MIDLAND ENERGY CENTER PROJECT
MIDLAND DOCKET NOS 50-329, 50-330
SAFETY EVALUATION REPORT INFORMATION
FILE 0505.16 SERIAL 20427

INFORMATION REGARDING REACTOR VESSEL HEAD VENT

INFORMATION REGARDING LOCKED ROTOR ACCIDENT

FIGURE 1: High Point Vent System for Loop A

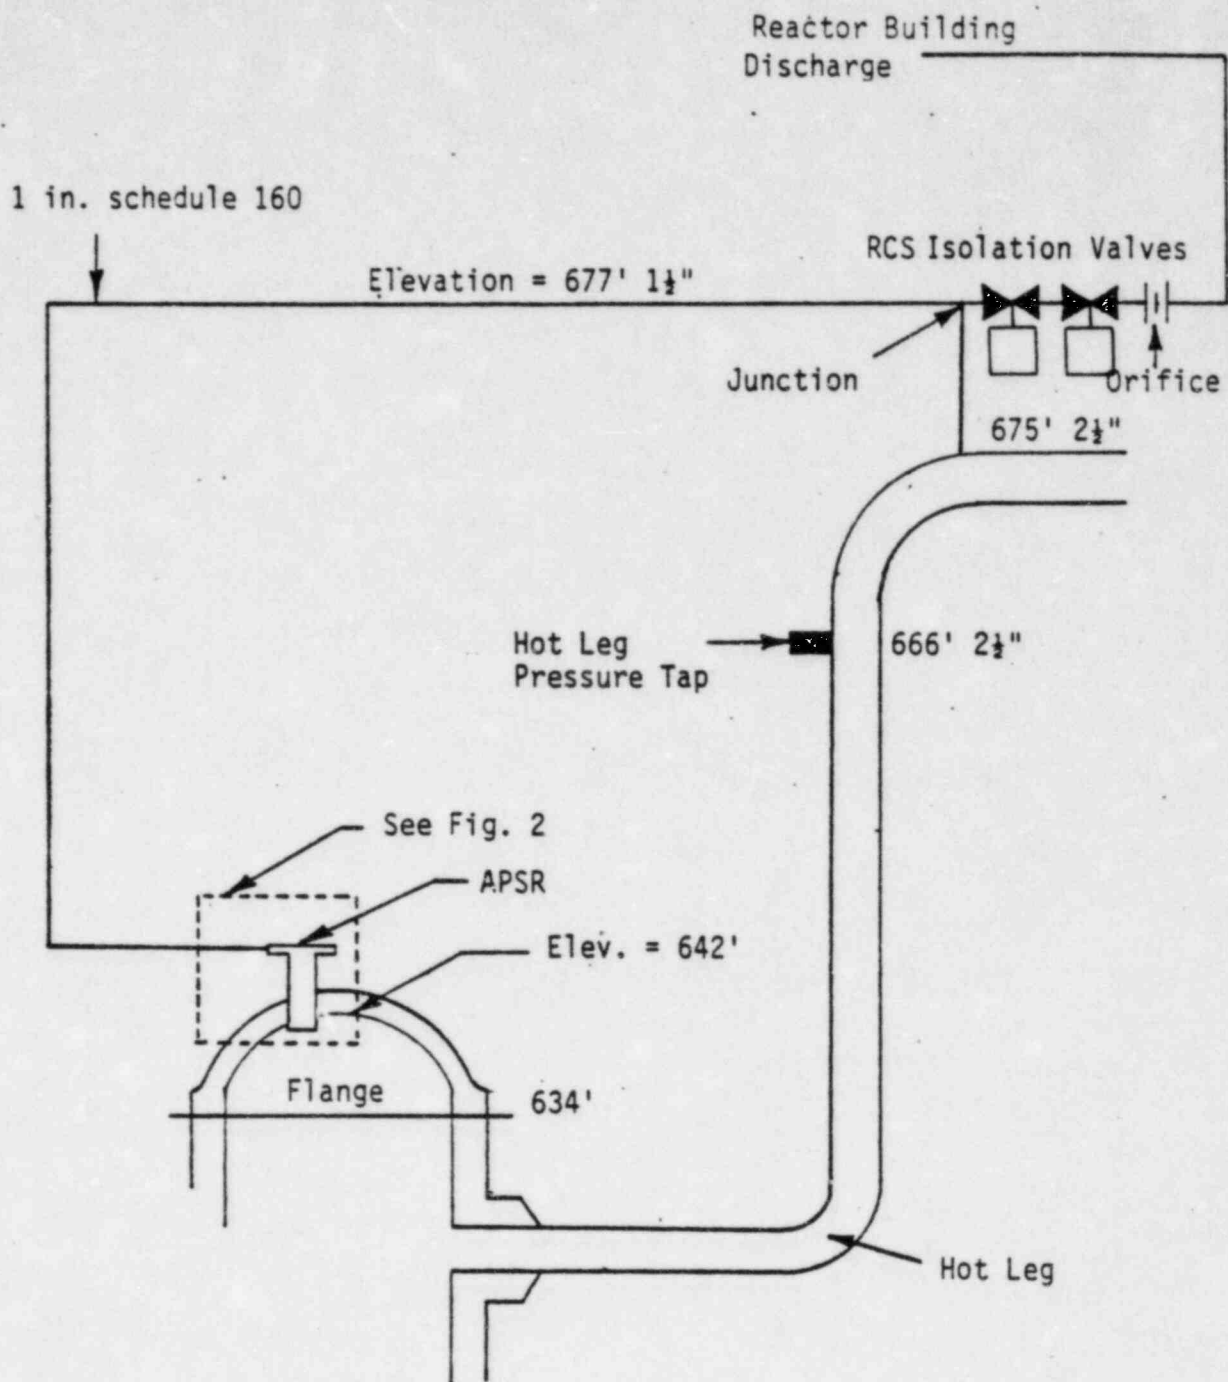
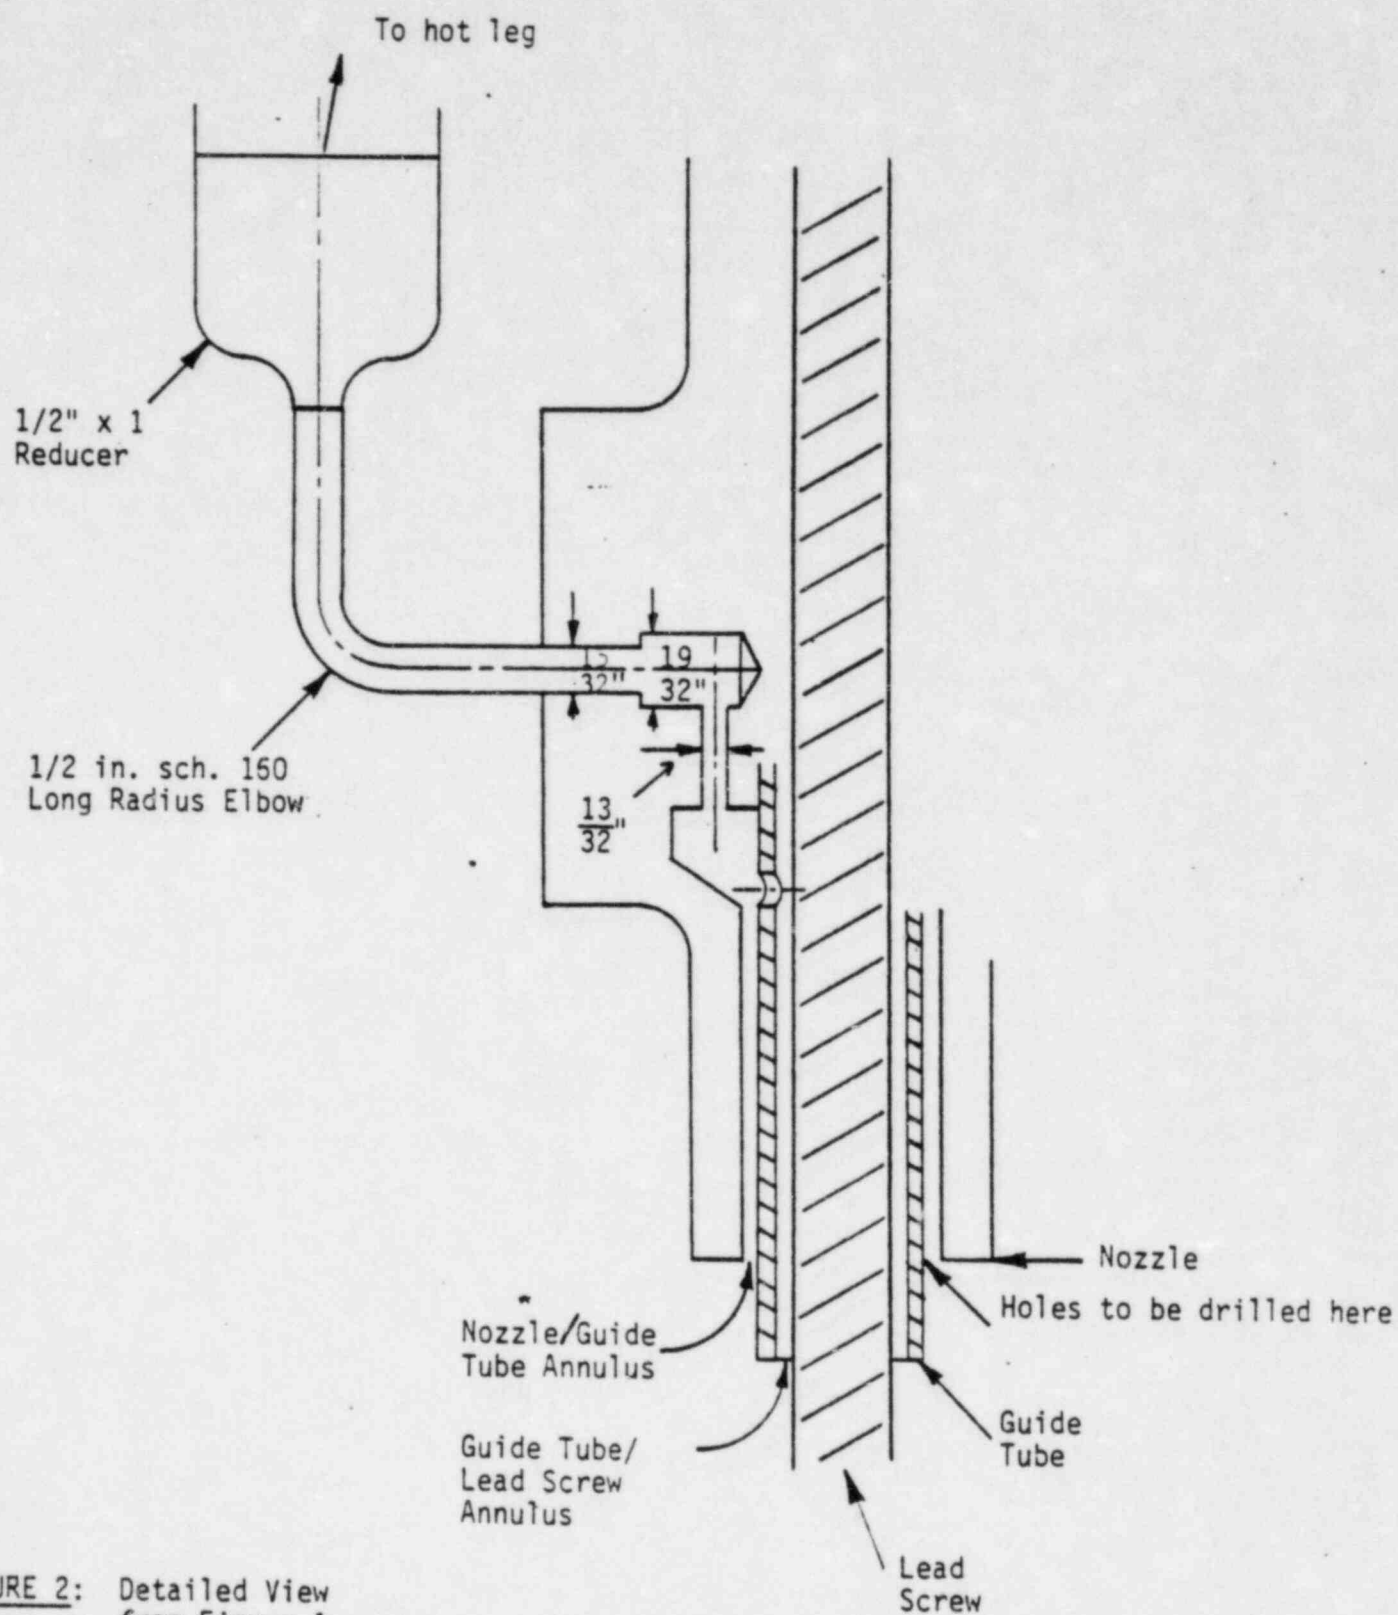
1. Provide a description of operator action and procedures for utilizing the reactor vessel head vent proposed in your letter of August 26, 1982.

RESPONSE: The reactor vessel head vent proposed by Consumers Power Company will be located in the region of the APSR mounting flange to provide a continuous vent from the RV head to the high point vent of one hot leg.

Since the reactor vessel head vent is a continuous venting system with no electrical or control systems involved and all valves are manually operated, there is no operator action necessary and thus no procedures required for utilization of this venting system.

FIGURE 12: Vent Flow Rates for Steam-Steam Case

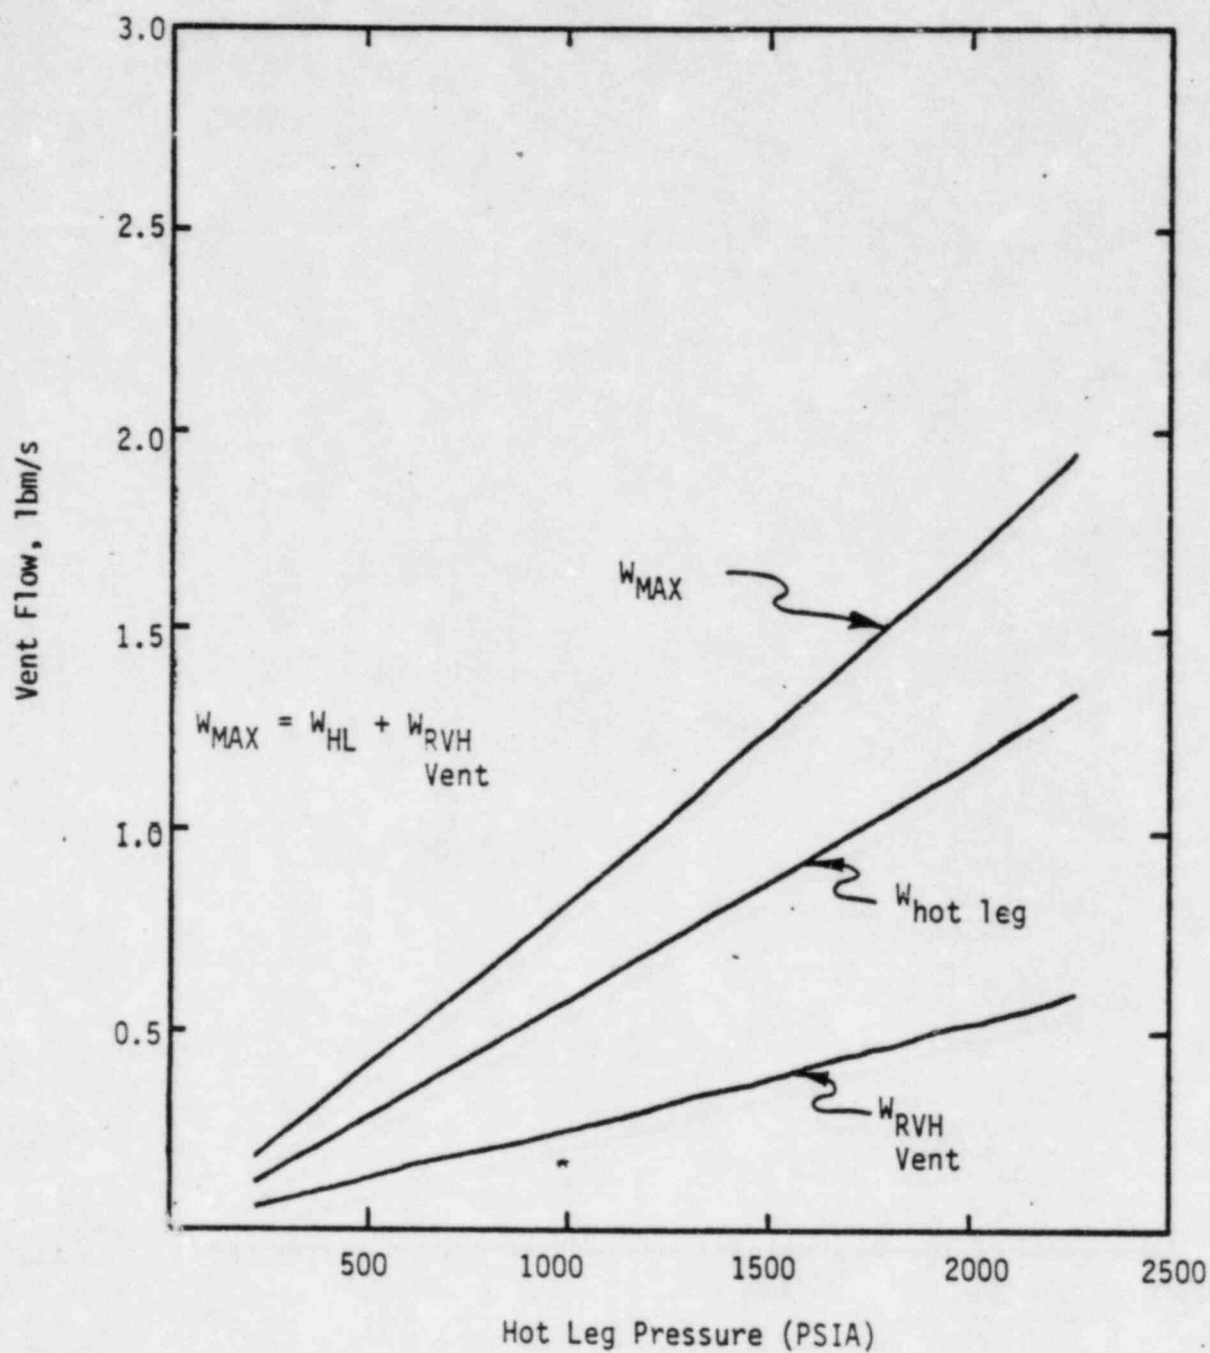
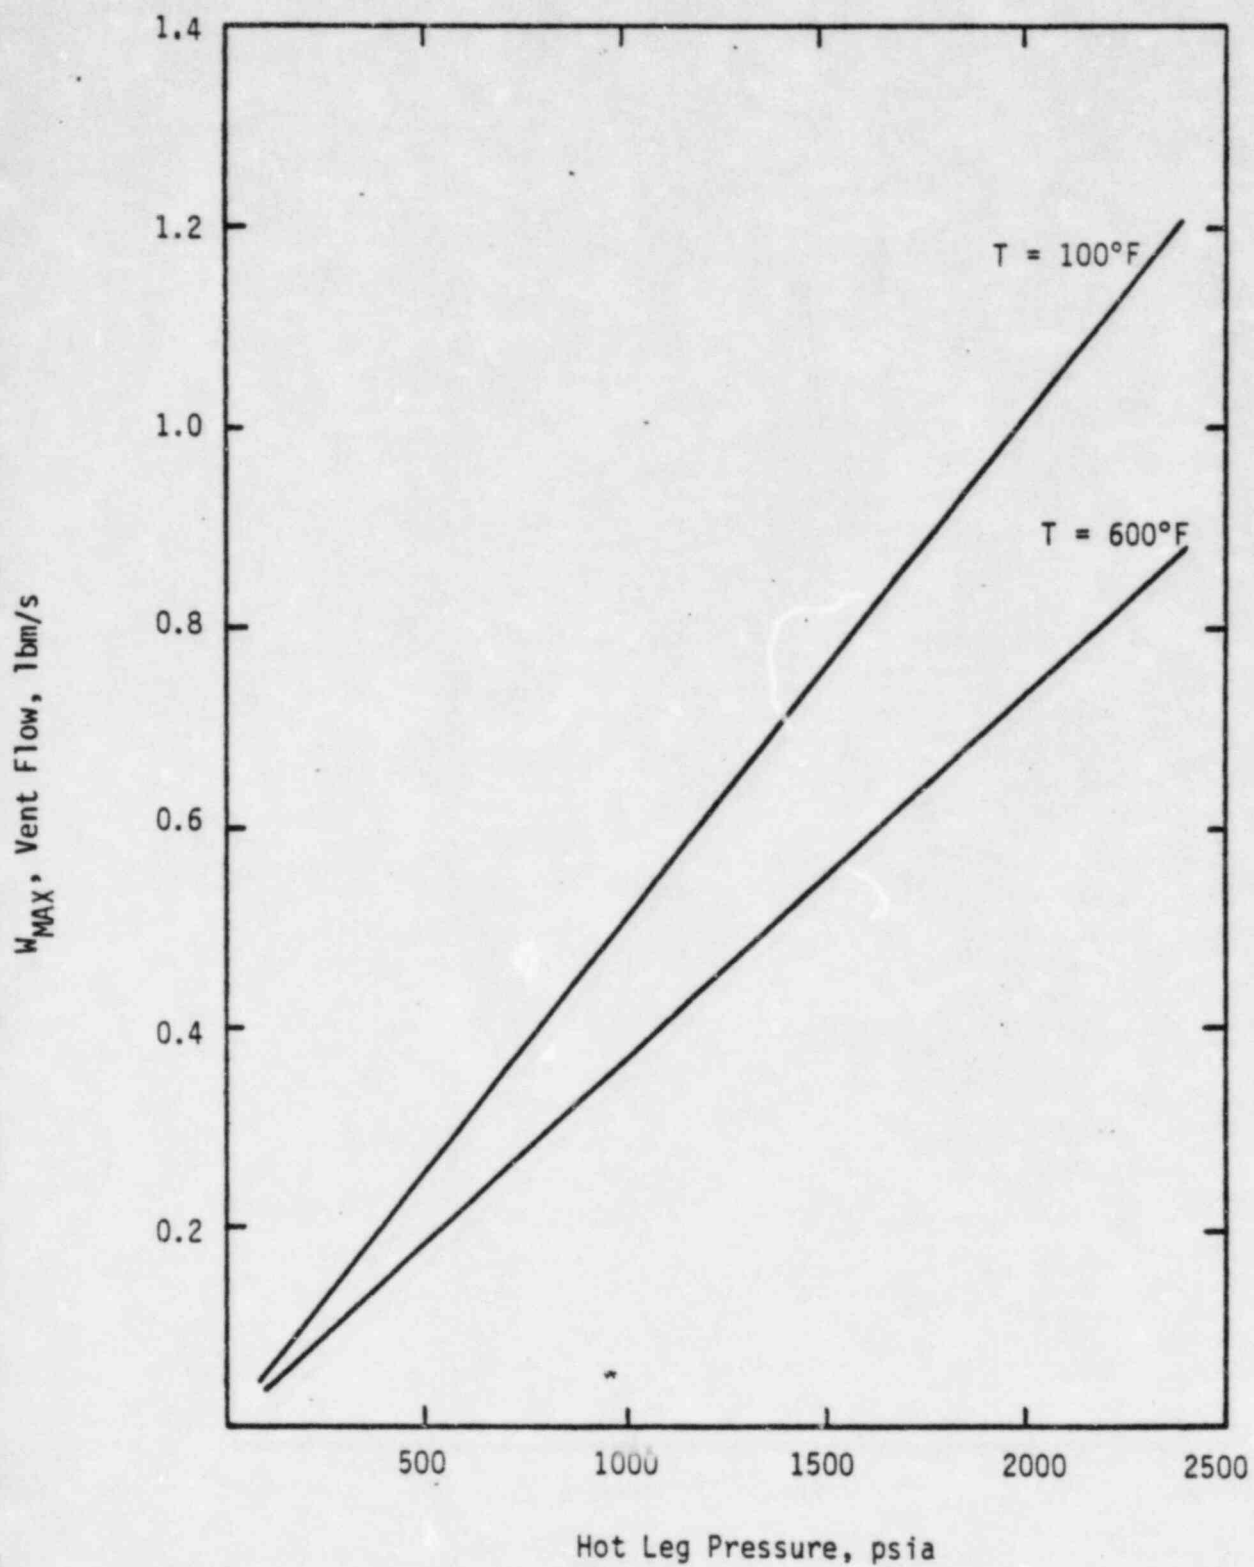
7. Provide the piping areas and the maximum venting rates for steam and hydrogen for the proposed head vent design.

RESPONSE: The requested information in the form of four figures is attached to this enclosure. The maximum venting rates through the reactor vessel head vent are based on venting to atmosphere through the hot leg vents.
